FirstEnergy Nuclear Operating Company

May 19, 2008
L-08-070

Beaver Valley Power Station, Unit No. 1
Docket No. 50-334, License No. DPR-66
Impractical American Society of Mechanical Engineers Code Section XI
Weld Examination Requirement (Request Nos. 1-TYP-3-RV-WELDS,
1-TYP-3-RH-E-1-2, and 1-TYP-3-SI-TK-2-1)

REACTOR VESSEL (RC-R-1)

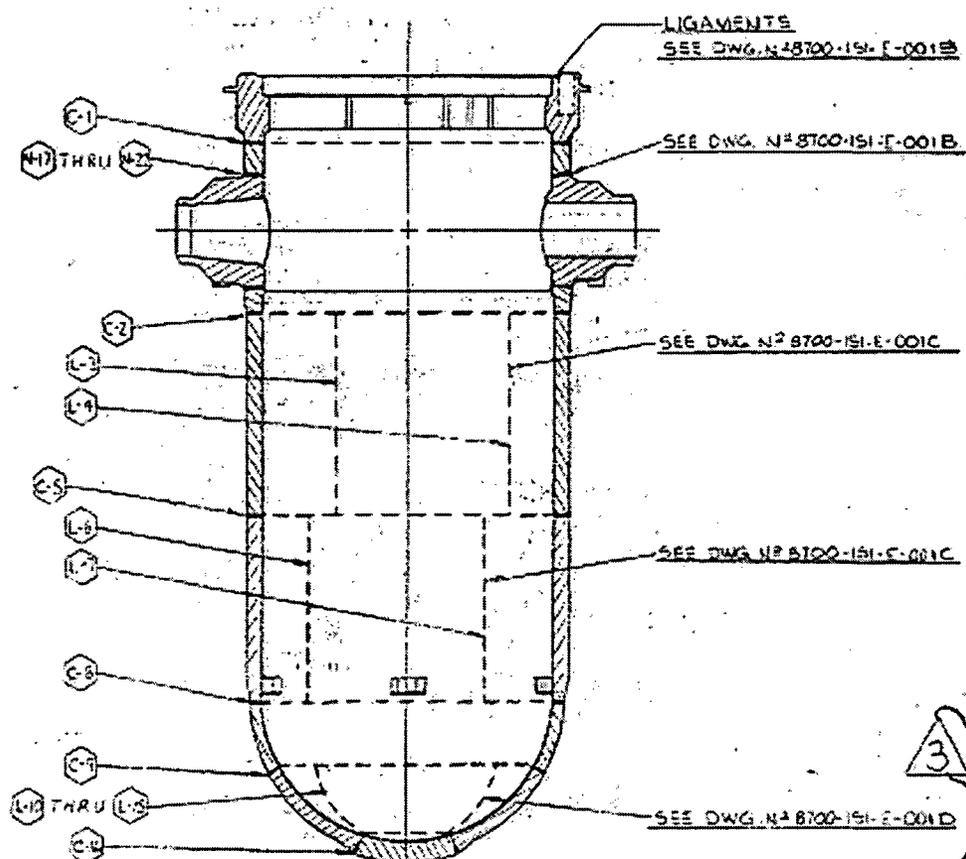
The 100 percent examination volume requirement for the affected welds has been determined to be impractical to obtain during the third ten-year inservice inspection interval due to component geometry in the case of weld C-1, and due to physical interference by the four radial support lugs in the case of weld C-8. Welds C-1 and C-8 are shown in the drawing provided on page 4. Examination limitations experienced are described in the paragraphs below.

The automated examination of the flange to shell weld C-1 was limited to 63.93 percent of the required volume due to the configuration of the flange. The proximity of the weld to the flange inside diameter taper transition limits scanning in both perpendicular and parallel directions to the weld below the transition. Additionally, four keyways and eight irradiation specimen slots limit scanning in the direction perpendicular to the weld from the area of the inside diameter flange face. Scanning was conducted between and below the obstructing keyways and between the irradiation specimen slots with the scan boundaries maximized by visually assisted positioning of the exam head so that scan starts and stops were as close to the keyways and irradiation specimen slots as possible. Extra transducers were also added to the exam sled and positioned in the fixture to maximize coverage. Two rotations of the examination head for both perpendicular and parallel scans were employed on the portions of the weld below the inside diameter taper transition. The extra rotations maximized the coverage by putting the extra dual element transducer in the proper orientation for additional near surface coverage for the perpendicular scans and transducers as near to the transition as possible for the parallel scans.

The automated examination of the lower head to shell weld (C-8) was limited to 80 percent of the required volume. The coverage limitation was due to the proximity of four core support lugs. Scanning was conducted between and below the obstructing lugs with the scan boundaries maximized by visually assisted positioning of the exam head so that scan starts and stops were as close to the support lugs as tool configuration would allow.

As an alternative to the 100 percent examination volume requirement, examination of reactor vessel circumferential welds RC-R-1-C-1 and RC-R-1-C-8 to the maximum extent practicable, which includes 100 percent of the weld circumference from the flange face (per ASME Code Section XI, only 50 percent of the weld was required to be examined from the flange face), is proposed. These examinations are supplemented by the visual examination performed on the interior of the vessel. The four support lugs and the flange to shell weld are included in this examination.

Ultrasonic test examinations coupled with the visual examination of the support lugs and the surrounding areas, and the visual examination of the interior surface of the flange to shell weld, provide adequate assurance of weld integrity.

RESIDUAL HEAT EXCHANGERS
(RH-E-1A + 1B)

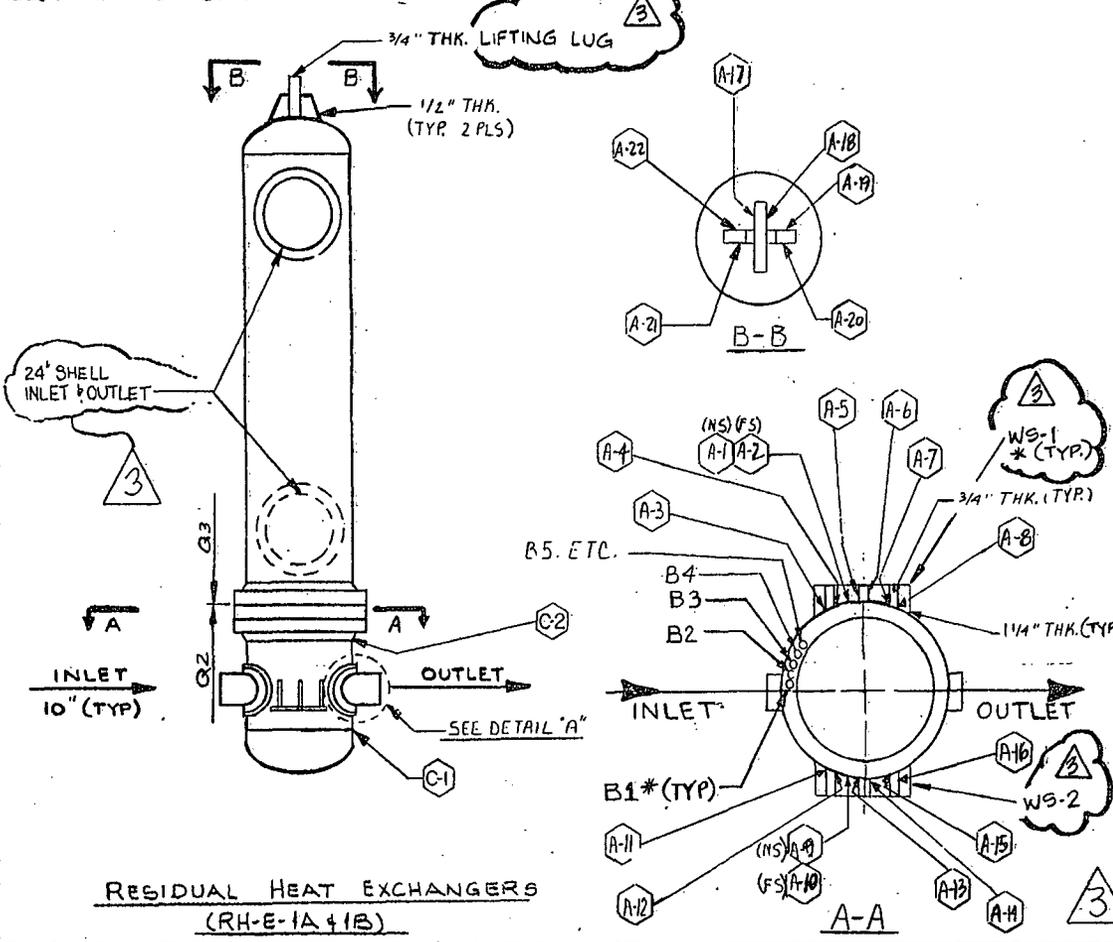
The 100 percent examination has been determined to be impractical because examination of weld C-1 during the third ten-year inspection interval was limited by curvature of the lower head and weld crown. Examination of welds C-1 and C-2 was limited by physical interference from welded support plates and inlet and outlet nozzle external reinforcing saddles. The 45 degree axial scans were supplemented with 60

Approximately 86 percent of weld RH-E-1A-C-1 and 71 percent of weld RH-E-1A-C-2 were examined in the third ten-year inspection interval. Since input values used to calculate coverage percentages are not precise, the calculated percentages differ between inspection intervals, even though the actual extent of examination does not differ and is the maximum extent practical. The examination limitations resulting from the curvature of the lower head and weld crown, welded support plates, and inlet and outlet nozzle external reinforcing saddles described above are common to both heat exchangers RH-E-1A and RH-E-1B. Relief is being requested because the actual coverage experienced during the third interval indicates that 100 percent coverage during the fourth interval would be impractical.

As an alternative to the essentially 100 percent examination volume requirement specified in Table IWC-2500-1, Examination Category C-A, examination of welds RH-E-1A-C-1 and RH-E-1A-C-2 to the maximum extent practical using a 45 degree axial angle, supplemented with a 60 degree axial angle, is proposed.

The heat exchanger shell adjacent to welds C-1 and C-2 is 0.875-inch thick, SA-240, TP304 material. Welds C-1 and C-2 receive VT-2 examinations in accordance with Category C-H, which would detect through-wall leakage. Complete VT-2 examination along with volumetric examination to the maximum extent practical would ensure continued reliability of these welds.
